## **DEVELOPMENT APPLICATION 2017.445 – LOT 1 DP 109606, 1070 PRINCES HIGHWAY, FROGS HOLLOW - RECREATIONAL FLIGHT SCHOOL**

RMS has reviewed the amended plans (refer to drawings with reference Project No. 180695, Drawing No. A1001, A1002, A1003, A1004, A2001, A3001, A4001, A5001, C1001, C1002, C1003, C1004, C1005, C2001, Rev B and dated 16.11.2018) and additional supporting information (Design Report dated 16 November 2018, Issue C and details on fights that will cross the Princes Highway) attached to the above emails while focusing on the potential impacts to the state road network. RMS as a result of its assessment notes and advises the following:

**Subject:** Attachment 1  
**Attachments:** C\_180695\_revB\_PLANS\_UPDATED FOR RMS REVIEW.pdf; Design Report\_Frogs Hollow Intersection\_ Issue C\_180695\_16.11.2018.pdf

Project:  
PROPOSED INTERSECTION WORKS  
SPORTS AVIATION FLIGHT COLLEGE  
1070 PRINCES HIGHWAY  
FROGS HOLLOW NSW 2550

Checked:	Project Number: 180695	Revision: B
Approved:	Drawing Number: A1004	Sheets in Set: 14

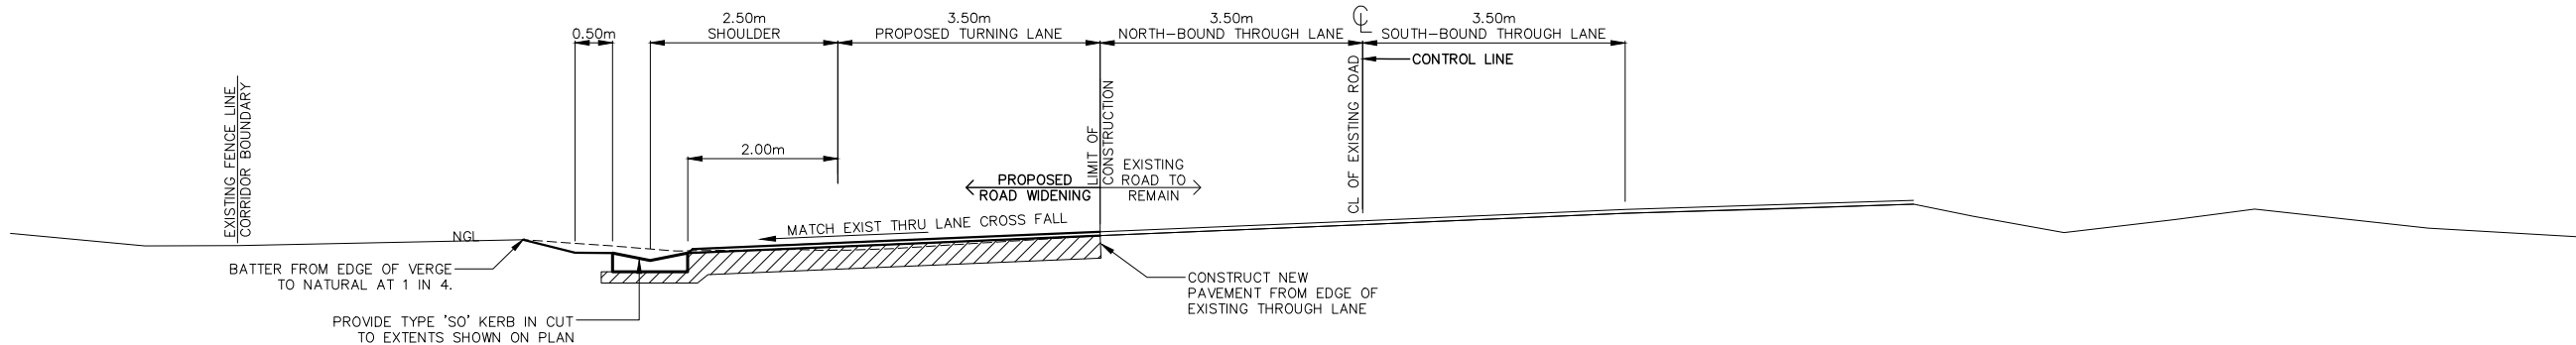
- Extend the guardrail at the northern end of the works adjacent to the south bound lane (by approximately 30 to 50m – refer to Drawing No.A1004, Rev B dated 16.11.2018) so as to capture the point of need.

Project Number: 180695  
Revision: B  
Drawing Number: A2001  
Sheets in Set: 14

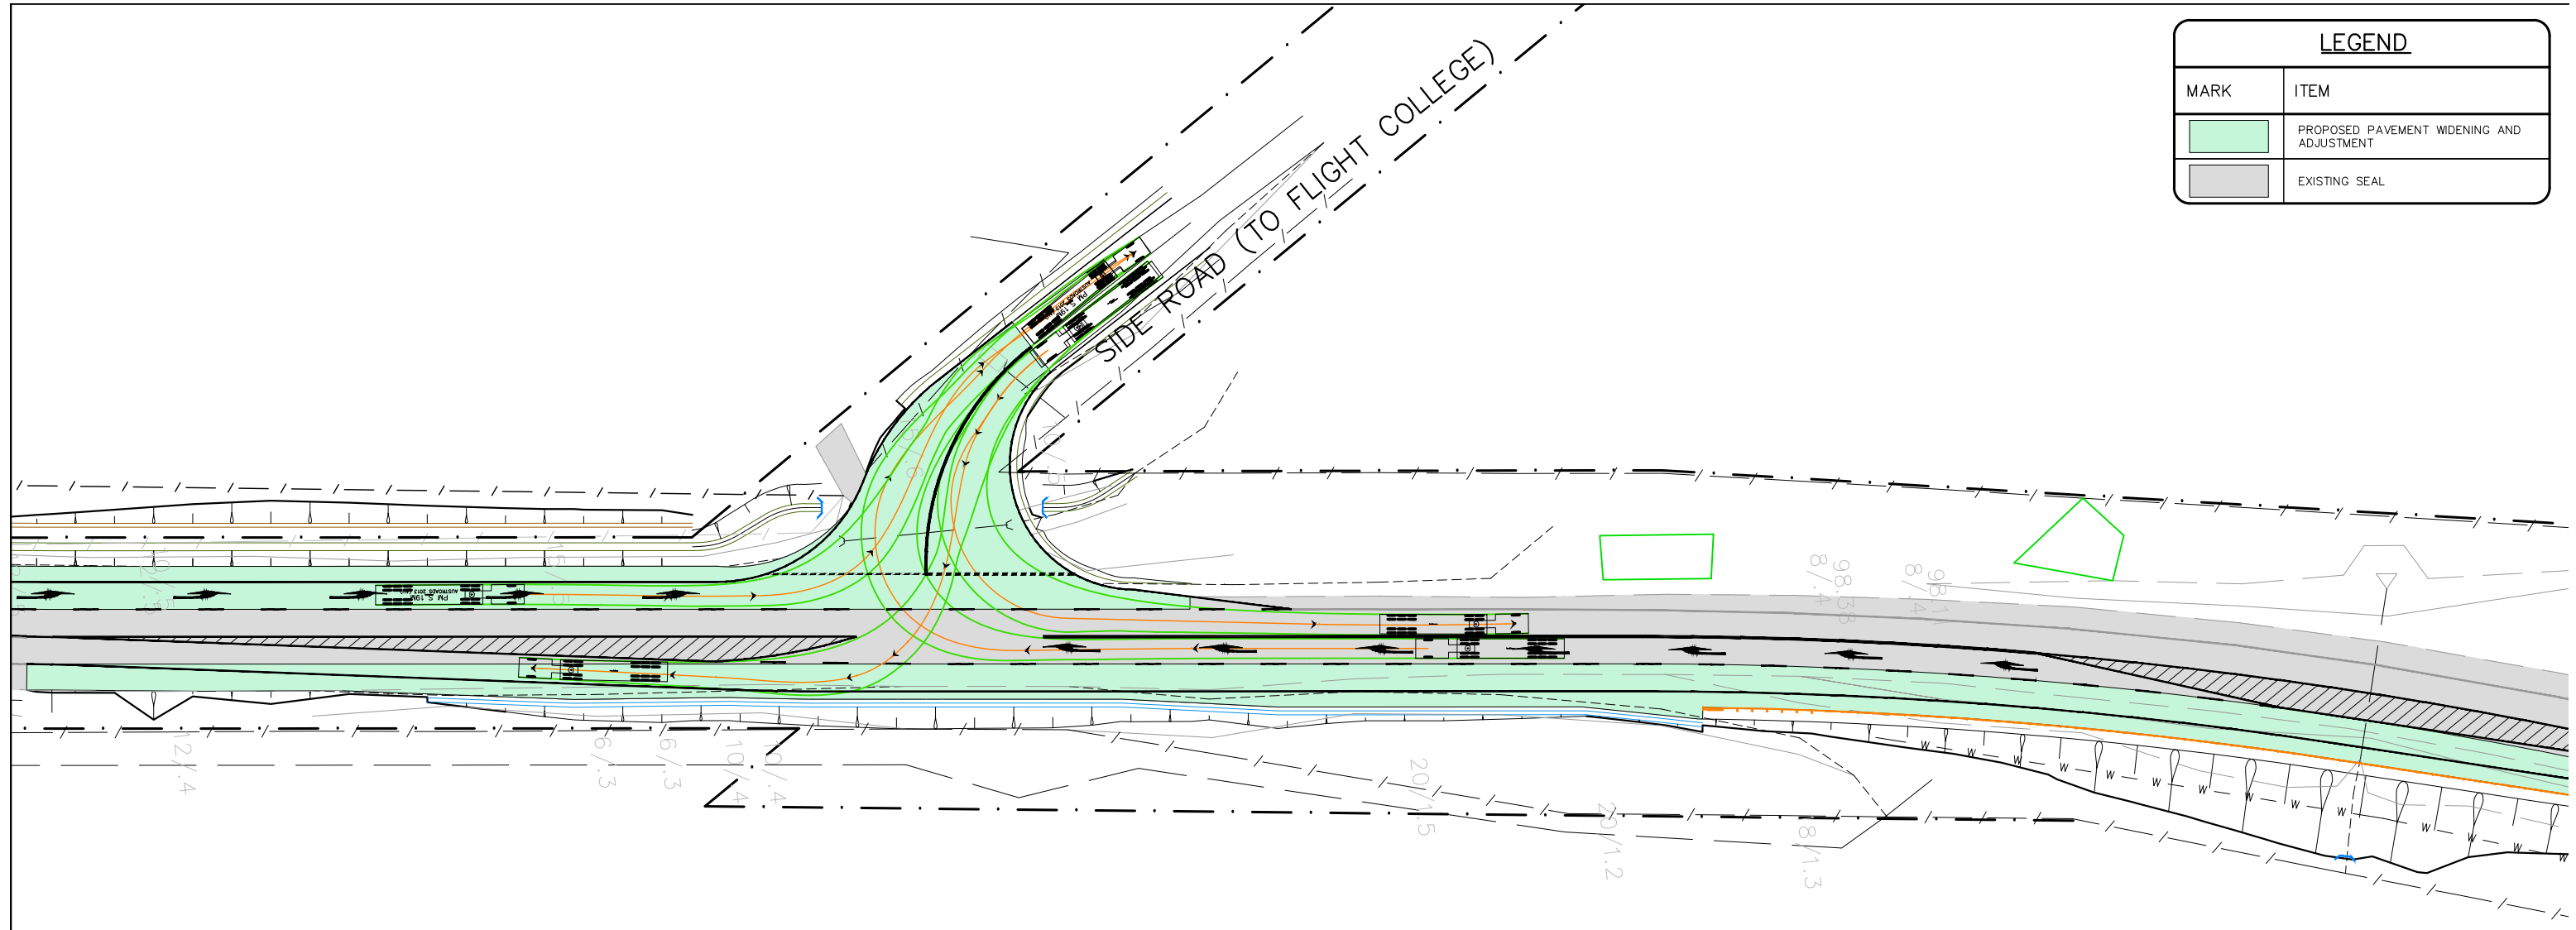
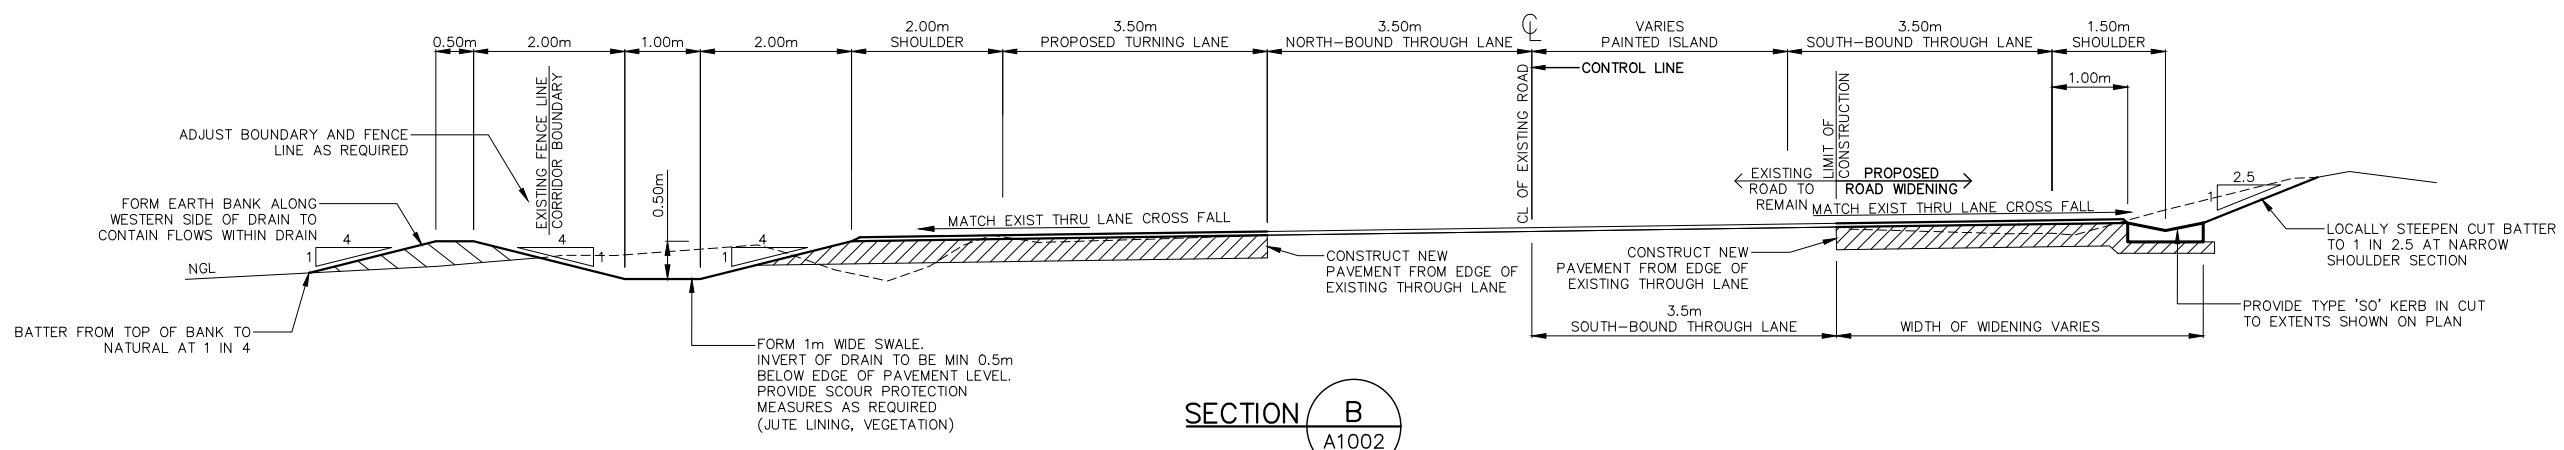
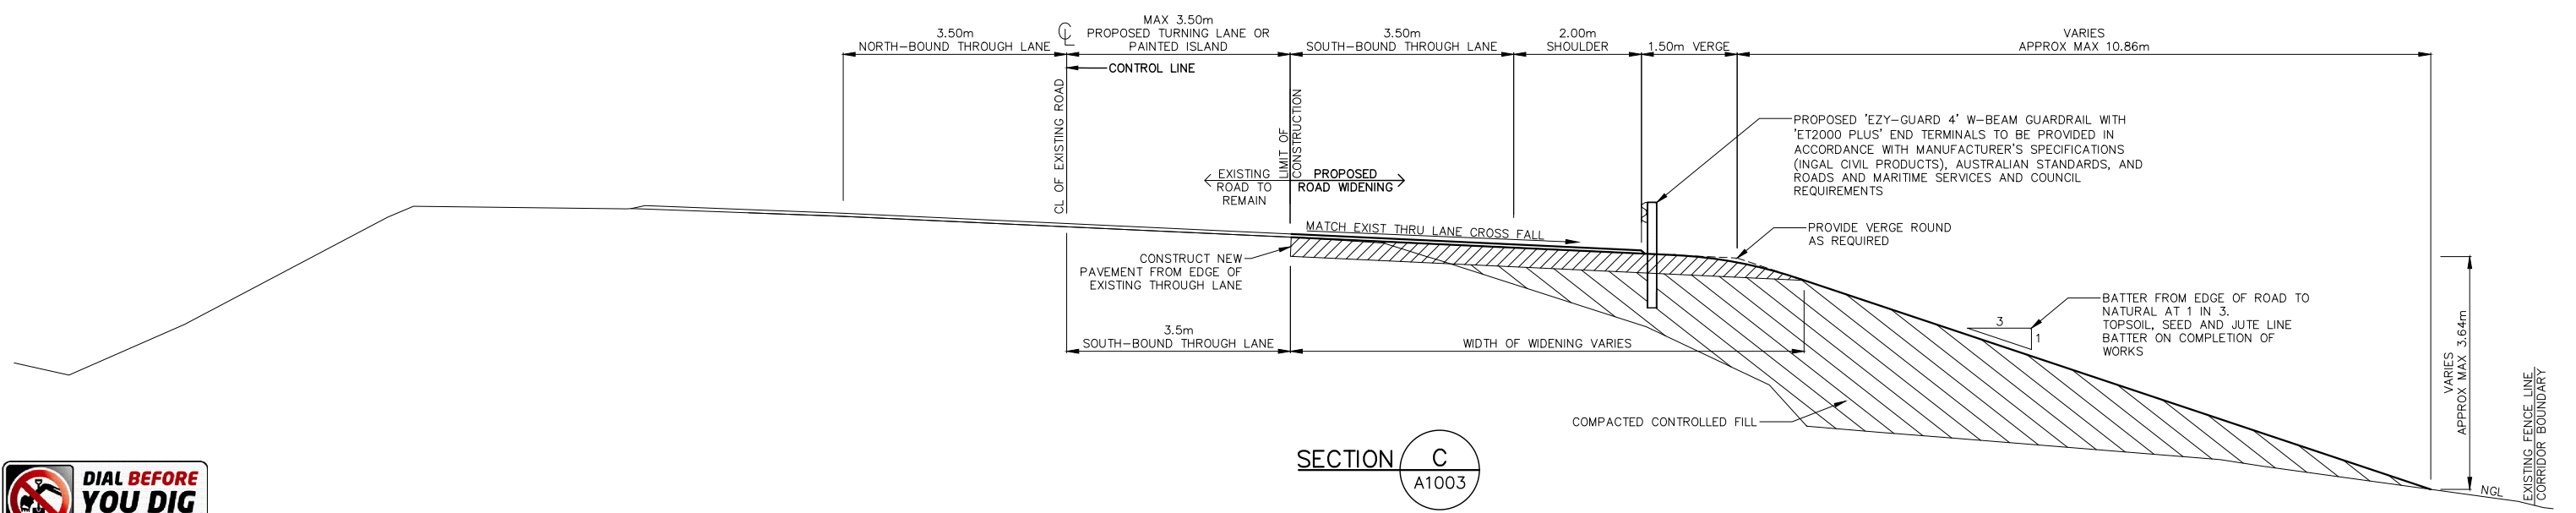
- **Cross falls should be a projection of the existing lanes (refer to Austroads Guide to Road Design Part 3: Geometric Design - Section 4.3.5 Shoulder Crossfalls);**

- Referring to Sections A to C (sheet A2001), the cross fall on the widening(s) is to match the existing road cross fall. Also shown in these Sections is that the widening of the road is to be from the edge of existing seal/shoulder; in other words, the existing shoulder is to remain and additional pavement added to the outside of the existing shoulder. Therefore, the proposed widening is proposed to match the cross fall of the shoulder. Based on the survey provided, the cross fall of the shoulder does not necessarily match the cross fall of the existing lane, and in some cases is quite different. Therefore the proposed widening cross fall will not necessarily match that of the existing lane, but will match that of the shoulder. This is why the cross falls on the outer lane and shoulder in the cross sections (C1001-1004) do not match the existing lane cross falls.

- Is it acceptable to have the widening match the shoulder cross falls? Note that the shoulder cross falls are generally steeper than the lane cross falls and fall away from the centre of the road. This will aid in reducing the risk of aquaplaning (see further comments below)

This issue needs to be resolved as part of the DA/prior to DA determination (i.e. in updated designs). **To assist a close contour spacing plan and edge line profile plan should be provided. ADDRESSED – widening and through lane re-alignments now match existing through lane cross falls. Aquaplaning Assessment Plan provided, showing close contours (see Sheet A5001). Edge line profile provided (see sheet C2001).**

Project Number: **180695** Revision: **B**  
 Drawing Number: **A5001** Sheets in Set: **14**

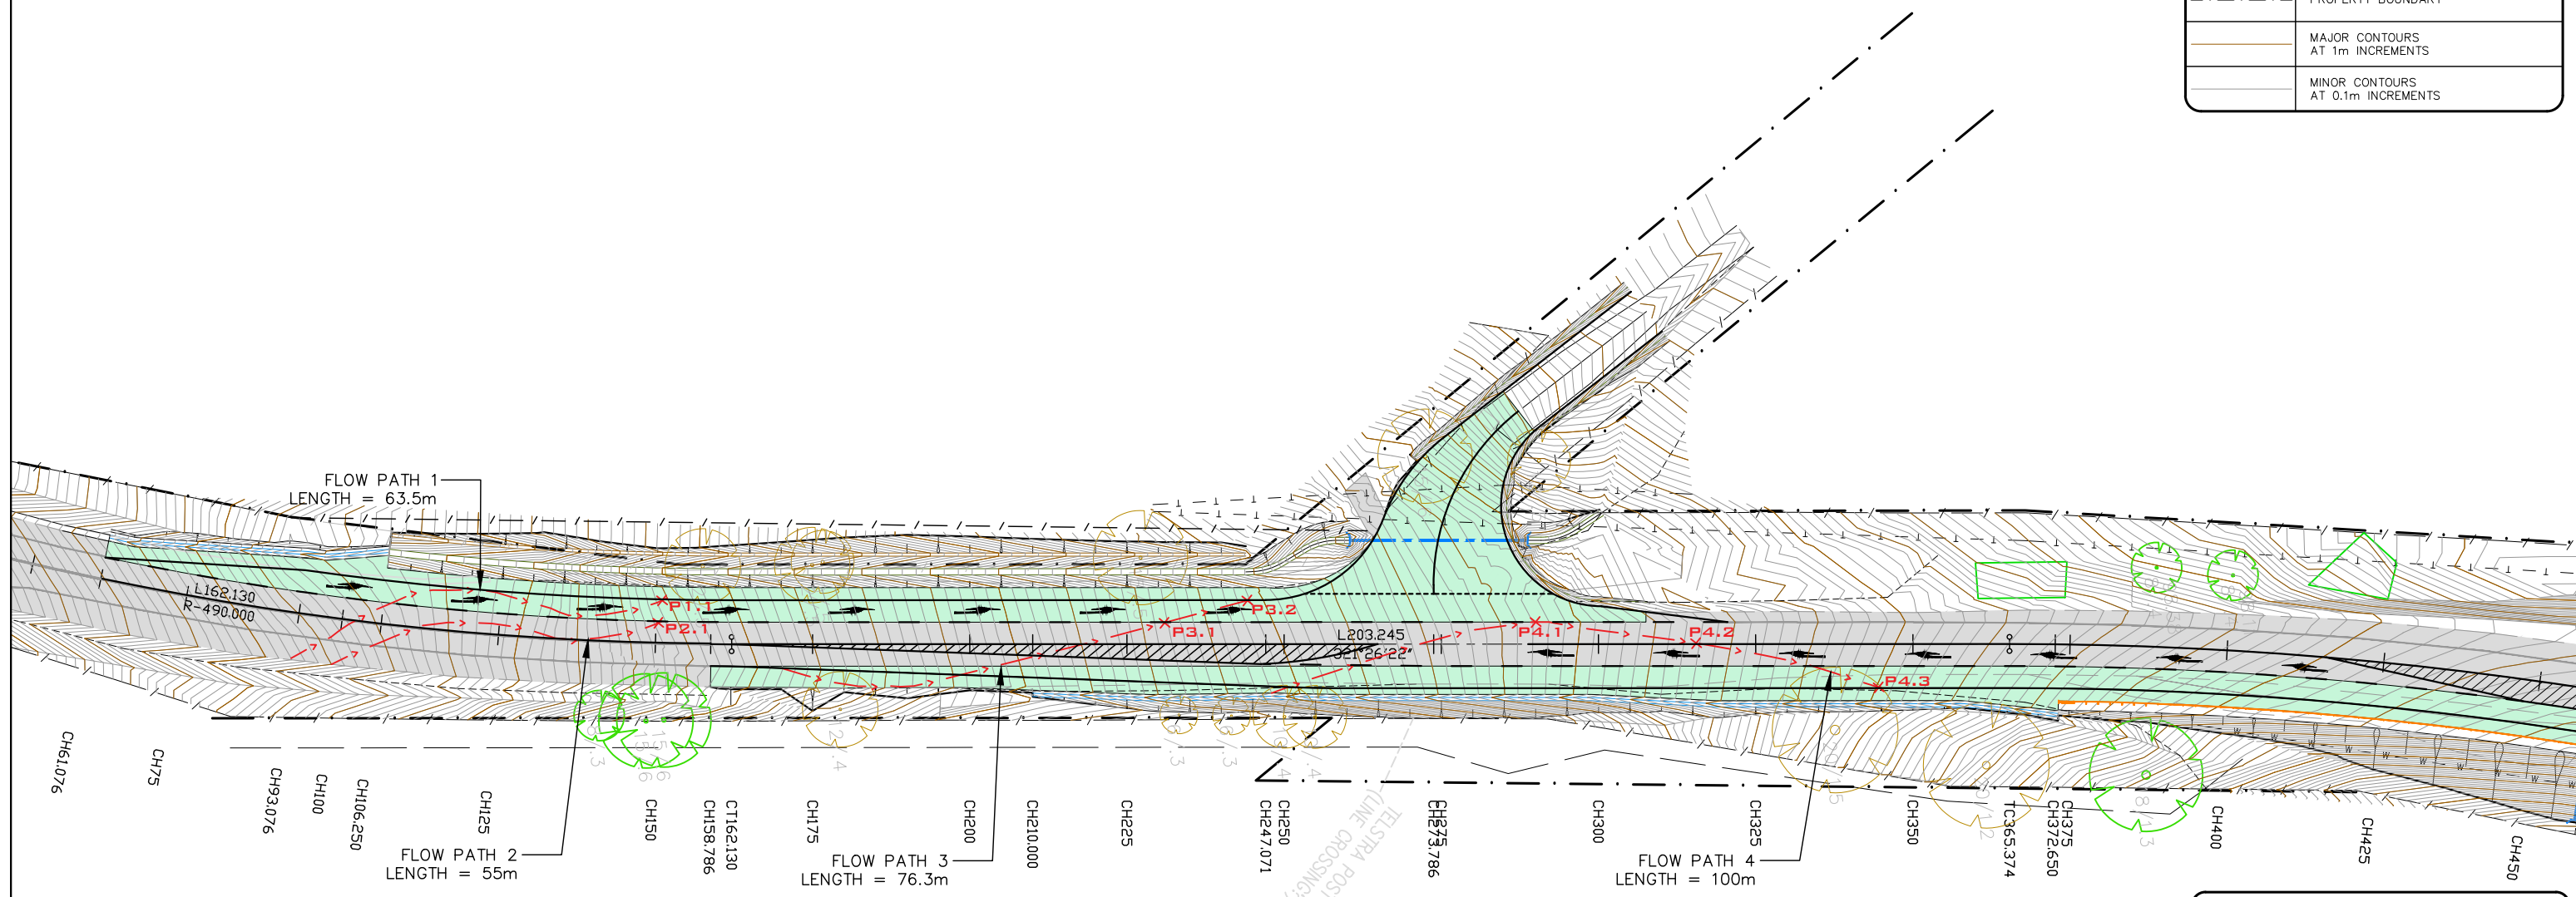
- An aquaplaning assessment needs to be undertaken to ensure the extra pavement width doesn't introduce any surface flow problems (refer to *Austrroads Guide to Road Design Part 5A: Drainage – Road Surface, Networks, Basins and Subsurface - Section 4.3 Assessment Process*);
- An aquaplaning assessment can be undertaken. Visual inspection of the contours suggests that surface flow paths are relatively long on the existing road. The widenings don't appear to add substantial lengths based on the current design, noting that the widening cross falls match the existing shoulder cross falls which are generally steeper than the adjacent lane cross fall and generally fall away from the road.
  - If assessment shows that the existing flow paths are hazardous and the widening make negligible difference, what will be RMS's approach?
  - Please discuss further as required

This issue (aquaplaning assessment) needs to be resolved as part of the DA/prior to DA determination. ADDRESSED – aquaplaning assessment has been undertaken – see report.

The results of the aquaplaning assessment are summarised in Table 1 below. The location of the flow paths and points is provided in the Drawings (see sheet A5001 - Aquaplaning Assessment Plan). These flow paths and points have been determined through analysis of the surface contours with the likely worst-case points assessed.
